Software Version : EasyBuilder8000 V4.65.14

New Features

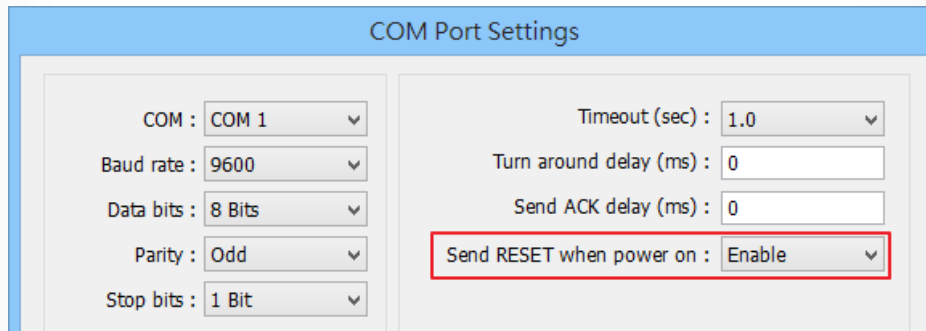
1. **SERVO BLDC (400/750WD)** driver is added.
2. **VIGOR VS Series** driver is added.
3. Fixed the problem where **Siemens S7-200 PLC** cannot communicate properly when switching the operation mode from Stop Mode to Run Mode.
4. Fixed the problem where the data cannot be correctly read due to noise interference when using **Mitsubishi Q00/Q00UJ/Q01/QJ71** driver.
5. Added [Send RESET when power on] option for **Mitsubishi Q00/Q00UJ/Q01/QJ71** driver. This feature is used for certain PLC types, which requires a reset during startup for communication to begin.
